RE: Eastshore Energy, LLC Preliminary Staff Assessment Comments  
Eastshore Energy Center (06-AFC-6)

Listed below, for CEC staff's consideration, are Eastshore Energy, LLC's comments on the Preliminary Staff Assessment (PSA) for the Eastshore Energy Center (Eastshore) project (06-AFC-06).

# **ATTACHMENT BIO-1**

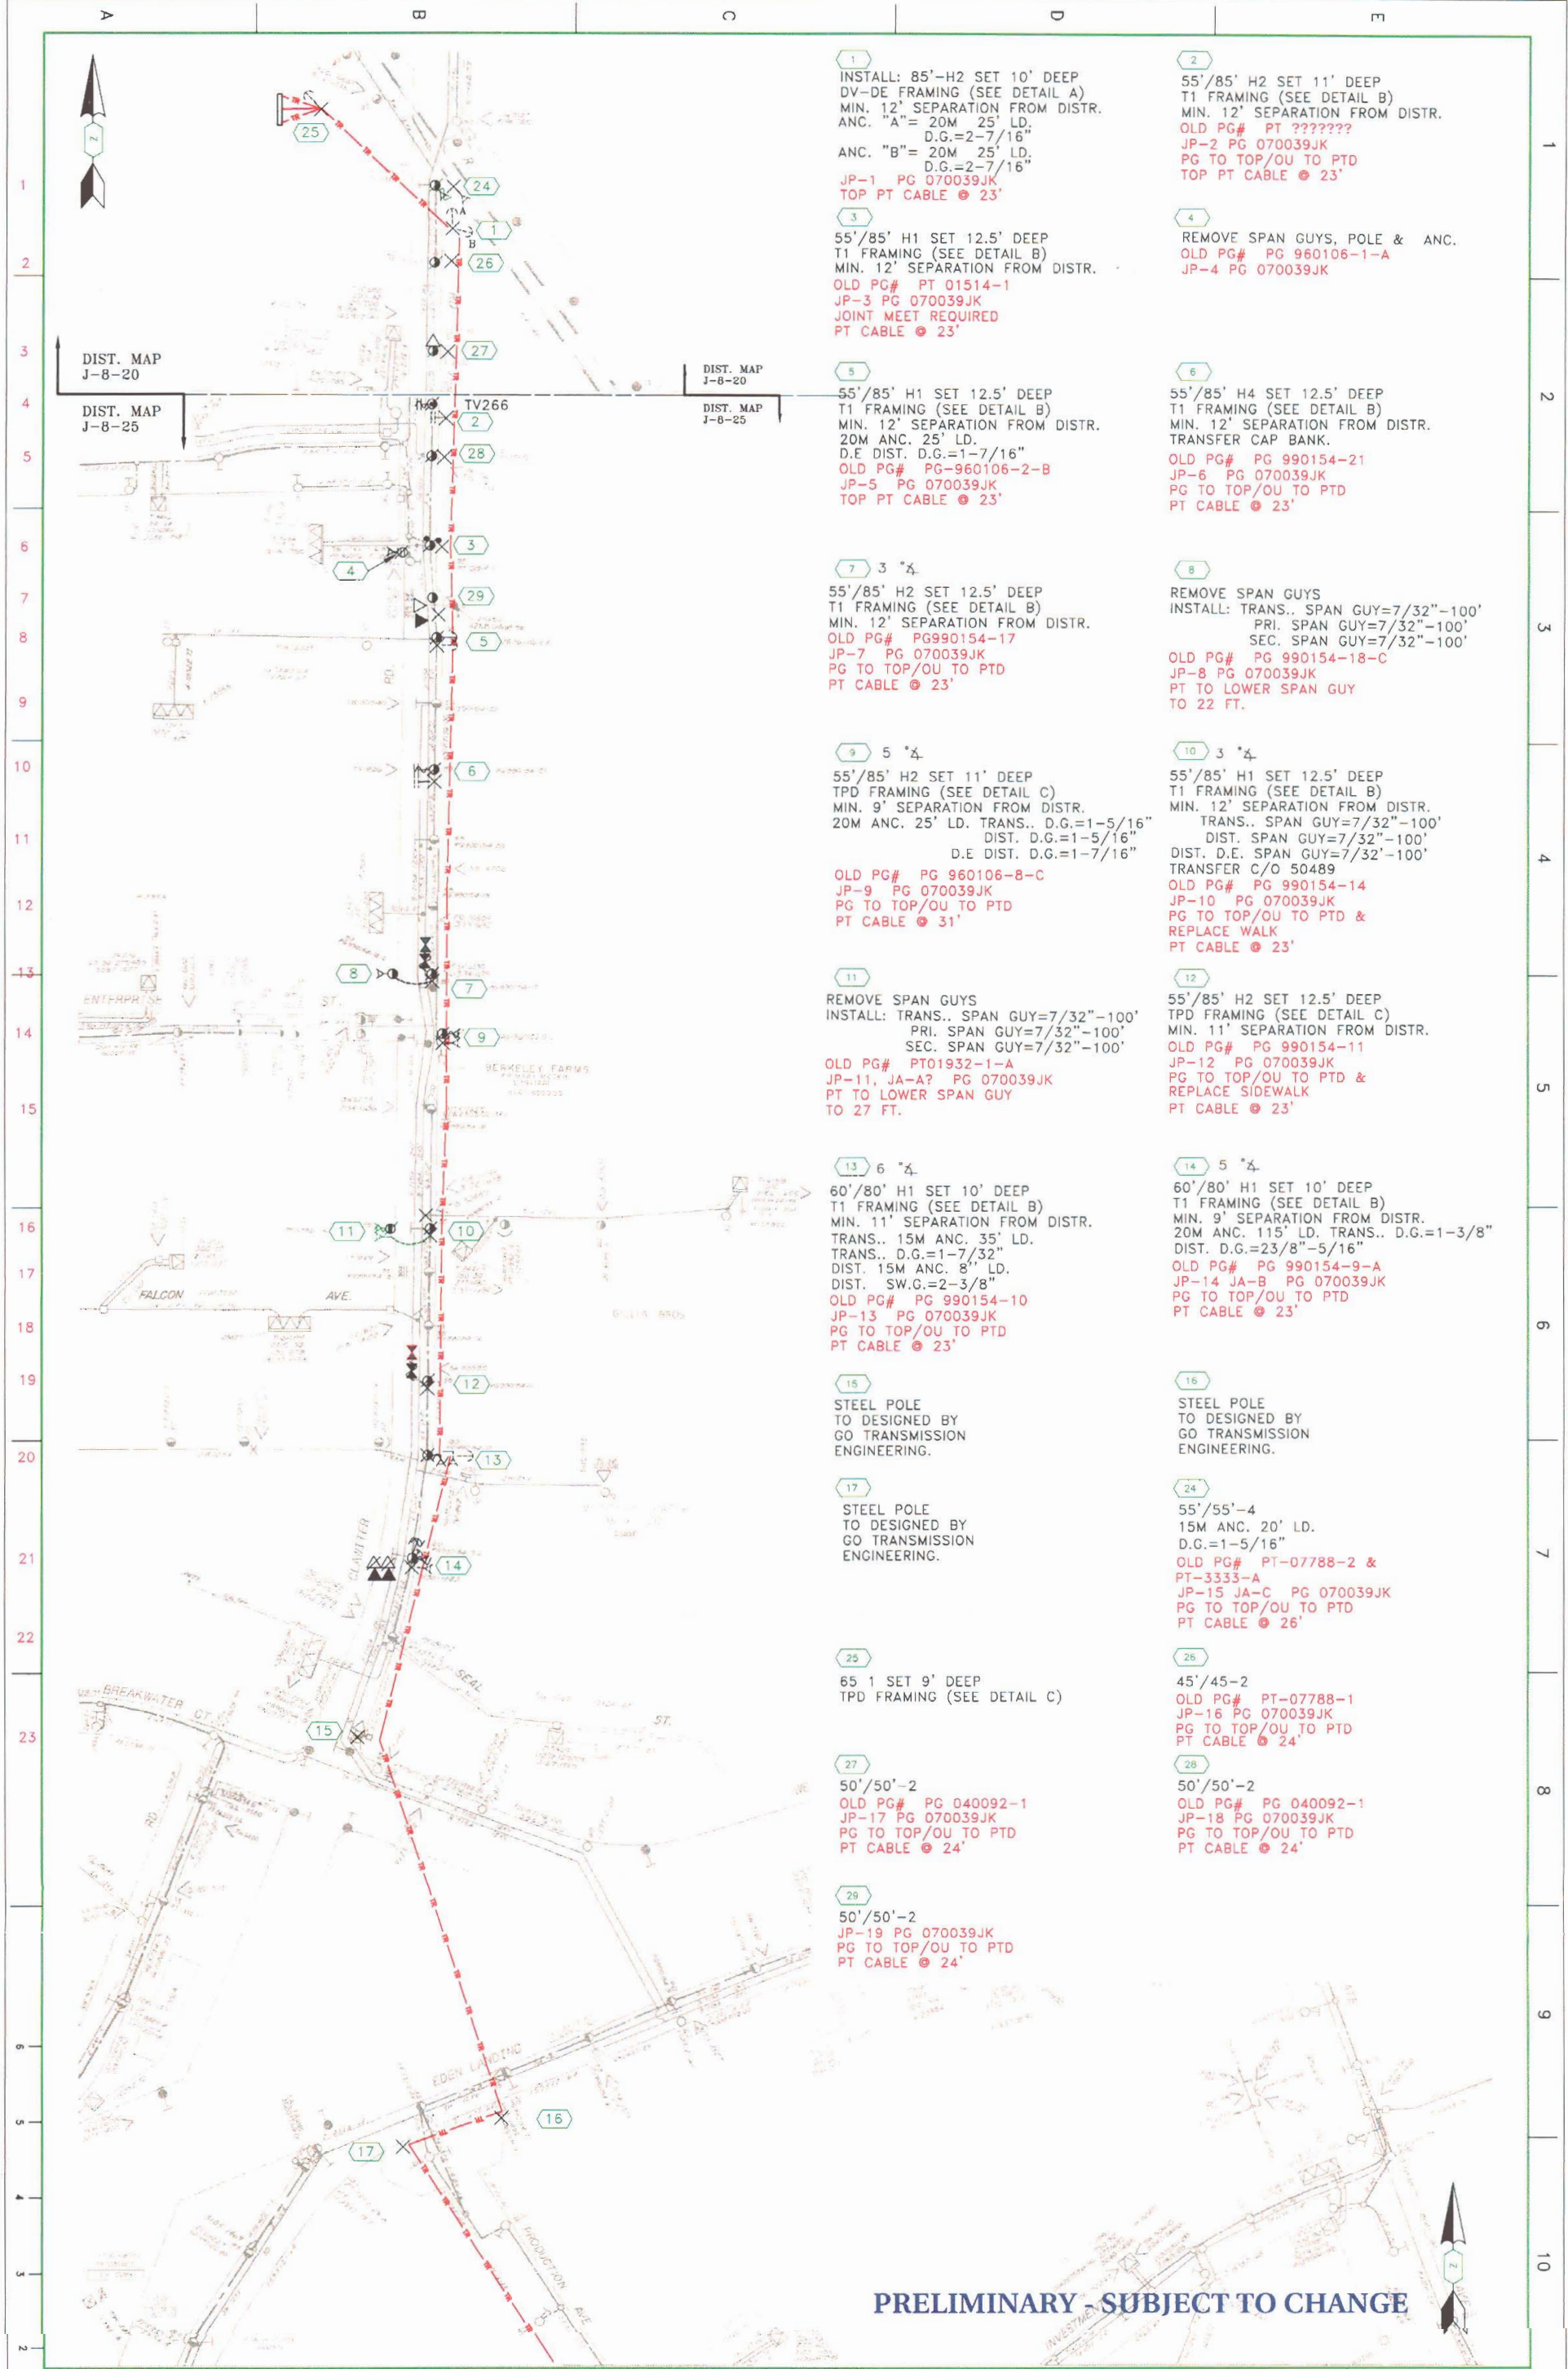
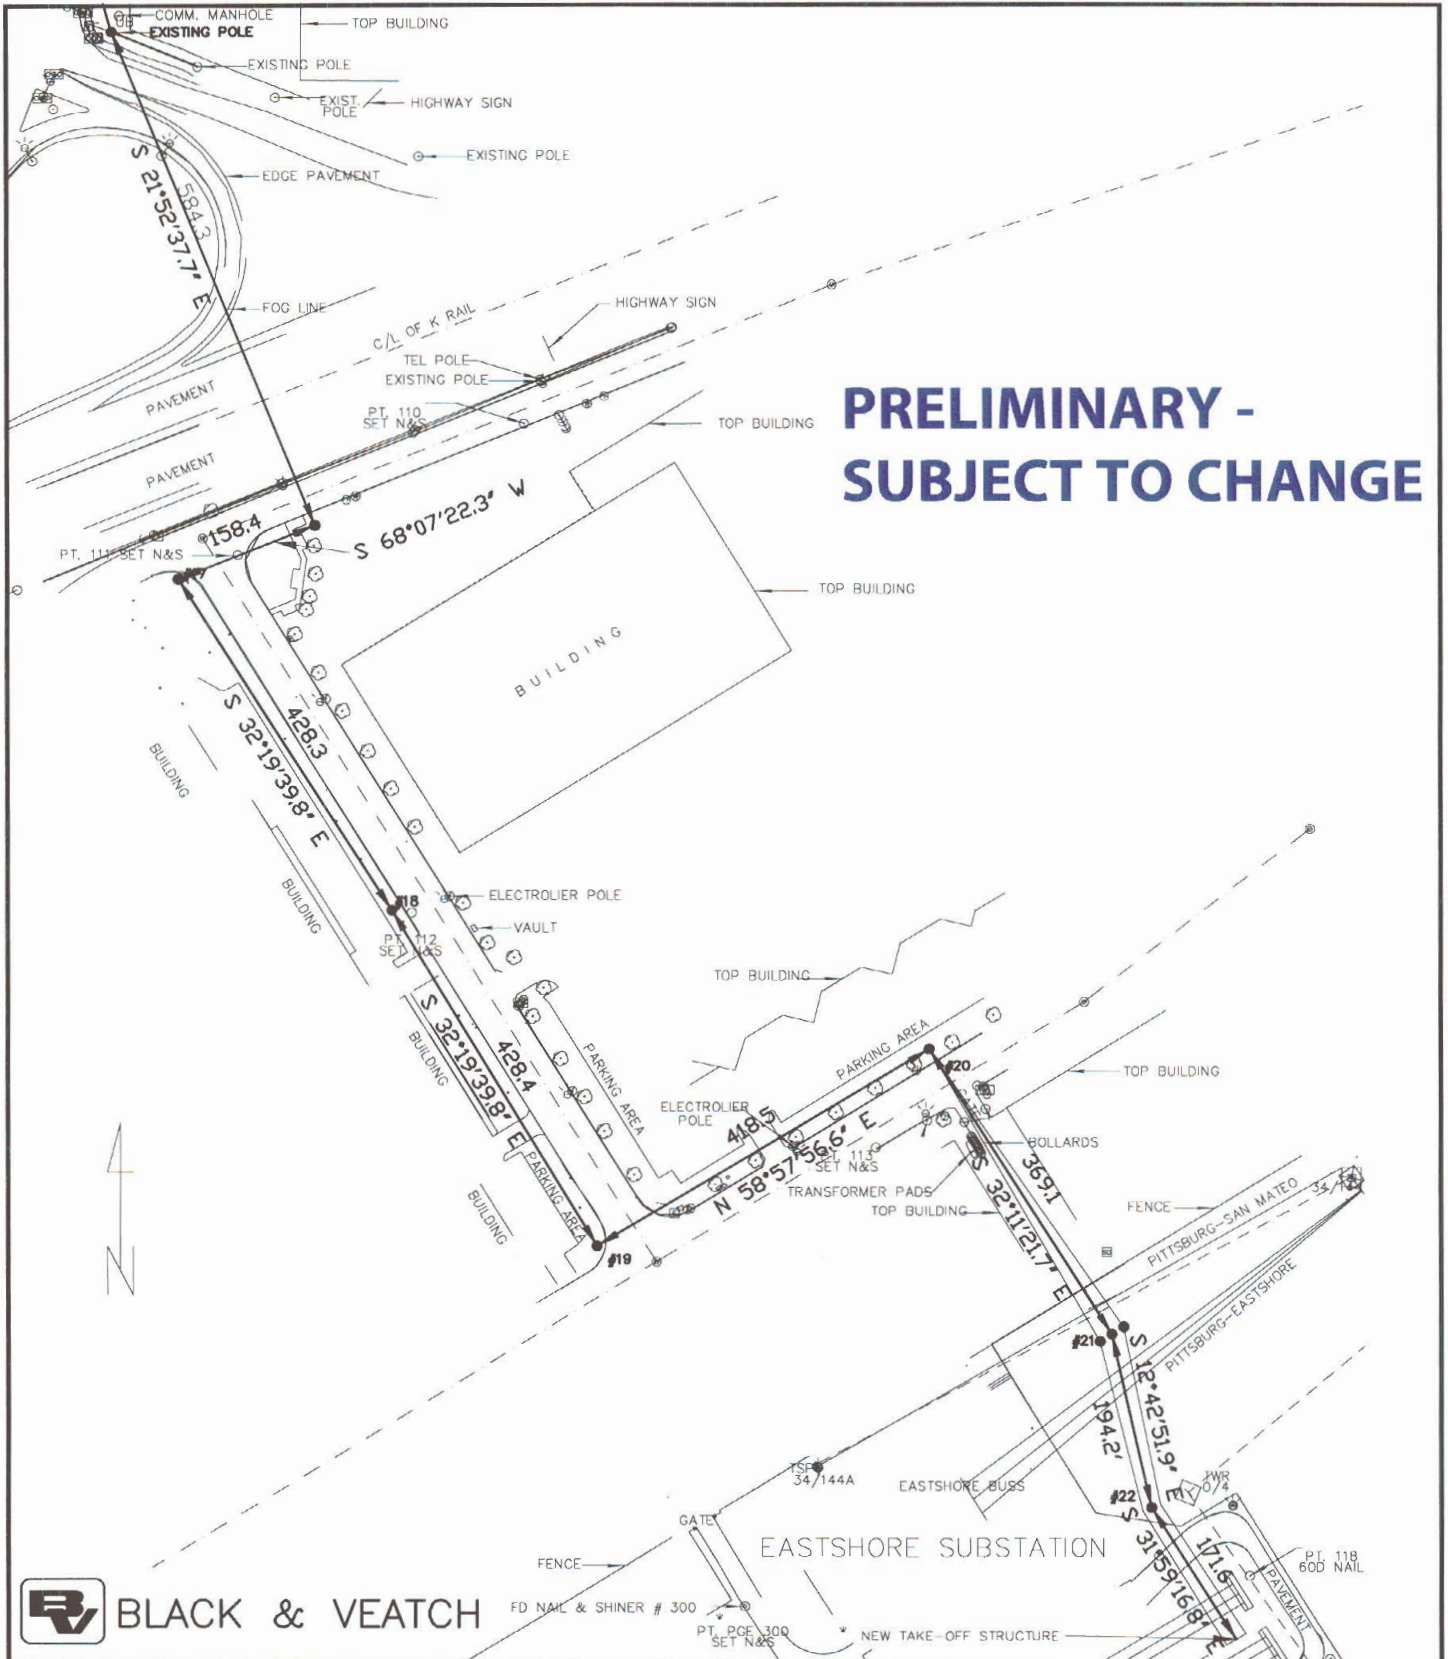
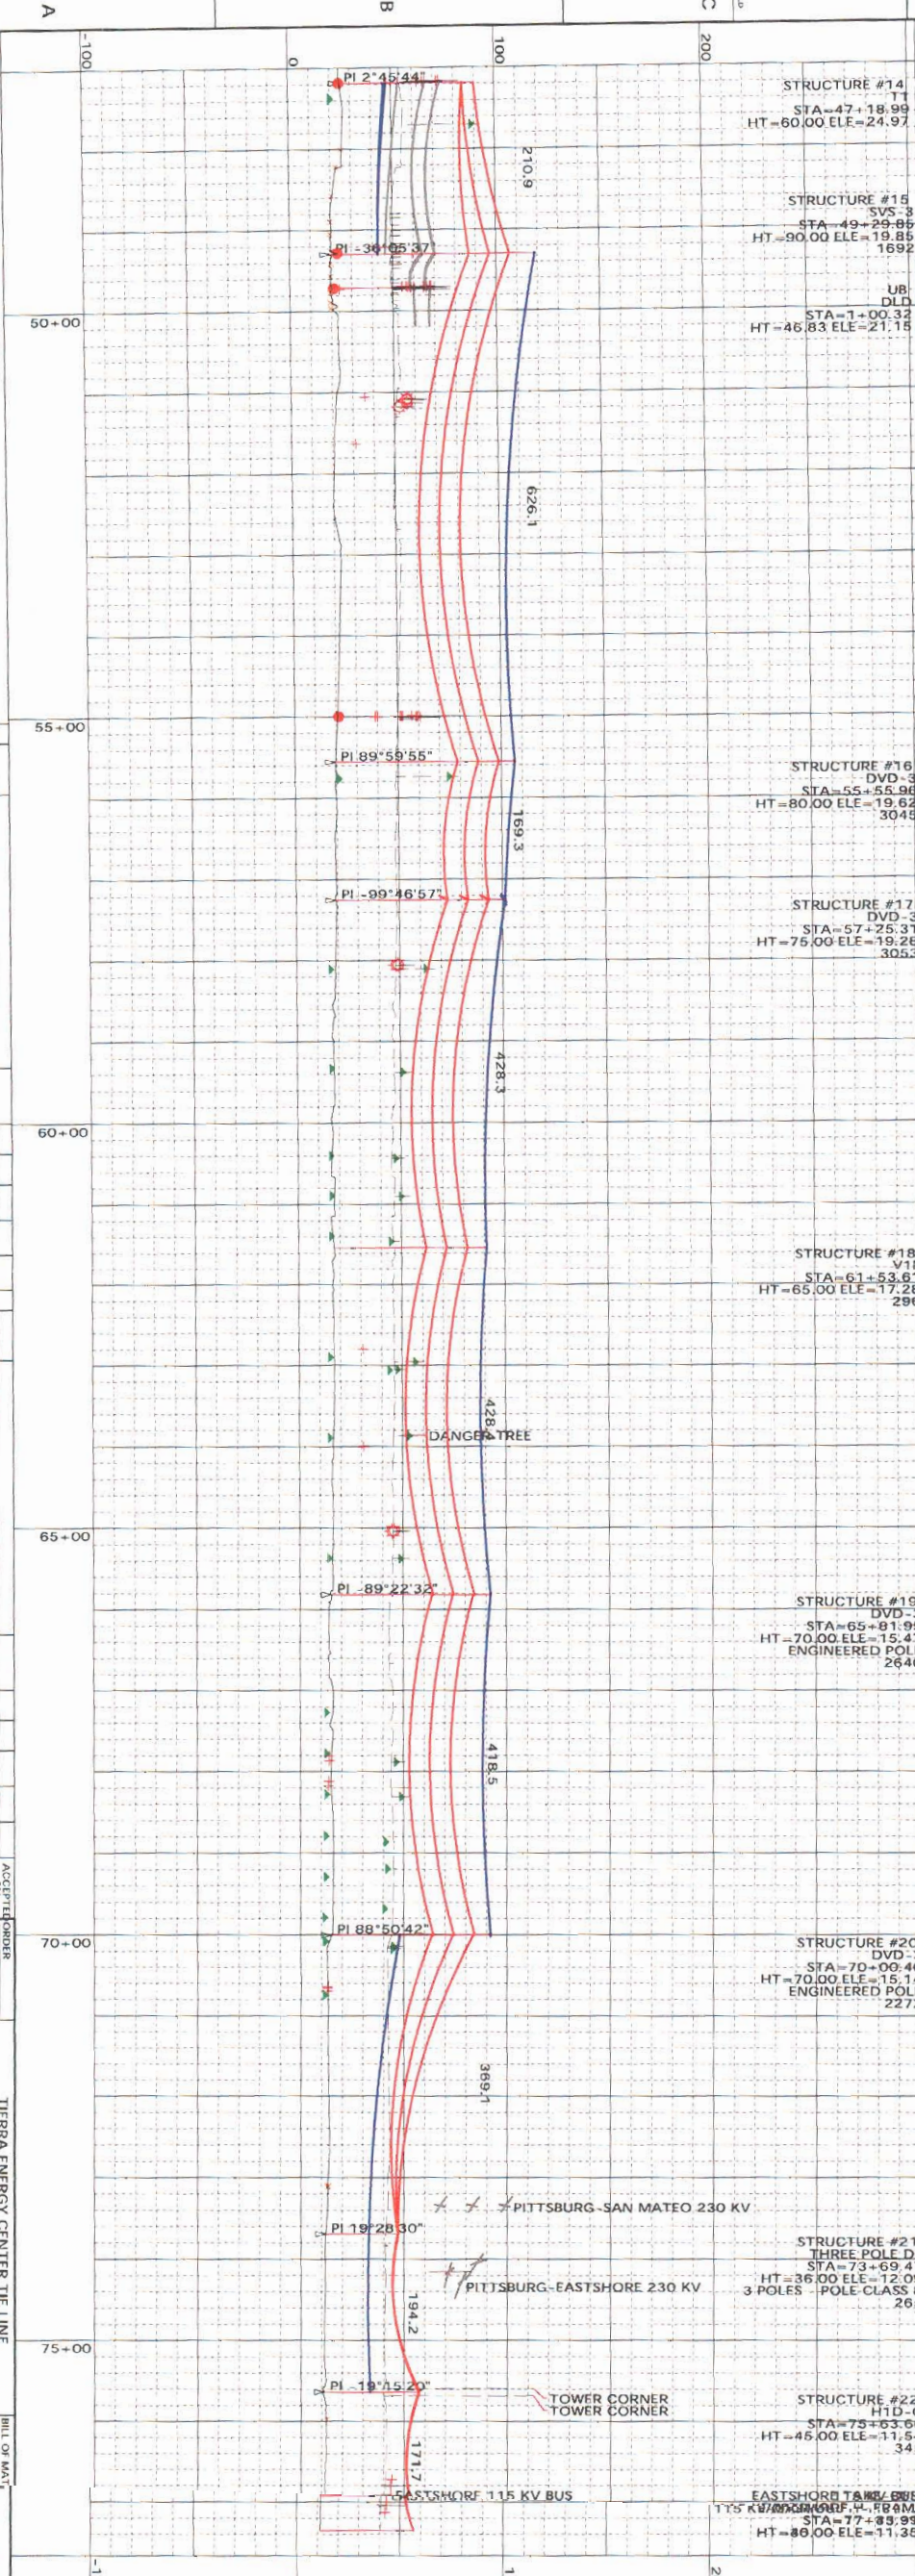
Page 4.2-9, under the discussion of "Sensitive Habitats", 2<sup>nd</sup> paragraph Attachment BIO-1 includes recent information from PG&E regarding the preliminary locations of transmission poles and structures that demonstrate the transmission line construction will not impact identified wetlands or burrowing owl habitat and should adequately address Staff's concern. However, if necessary, Eastshore would agree to a COC that requires that the transmission line not cross or otherwise impact identified wetlands on Eastshore substation property or burrowing owl habitat.

Page 5.5-1, regarding the sentence that reads, "PG&E transmission system... require analysis by PG&E and approval by California ISO", PG&E has completed the design of the 1.2 mile tie line as of mid-August, 2007 and all the structures and the route has been finalized. Please refer to Attachment BIO-1.

Page 5.5-4, under the discussion of "Project Description", please correct this discussion as follows: 80-foot pole structures will support the 115 kV transmission lines, the 85-foot pole structures will support the 115 kV transmission lines with 12 kV distribution lines, and a 90-foot pole structure will be placed on the south side and 60-foot on the north side of Highway 92. This information is based on the design of the 1.2 mile tie-line completed by PG&E as of mid-August 2007. Please refer to Attachment Bio-1.
